Proposed Deck Addition

2116 North Tejon Street

HIST-24-0008

Report of Acceptability

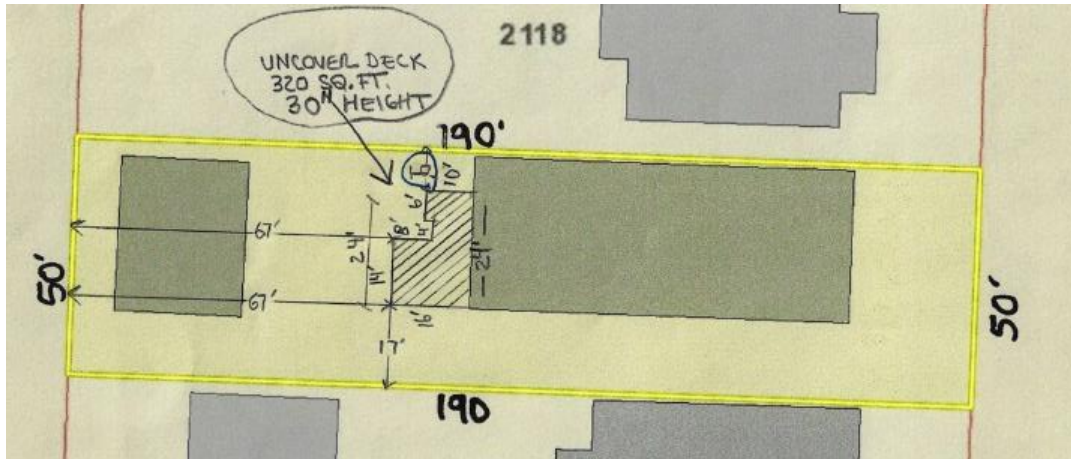
The Applicant has submitted a Report of Acceptability for a deck addition on the rear of the existing house located at 2116 N North Tejon Street (see "Attachment 1- Project Statement and Plans"). The proposed deck is 320 square feet. It has been aligned with the south exterior wall of the home to meet the side yard setback standards.

The proposed deck is being constructed in approximately the same location as a previously constructed deck (aka rear landing). The photo below shows the existing landing.

The new back deck is 30" above grade and its design, material and color are compatible with the existing residence. The rear elevation was altered in 2015 with a new addition.
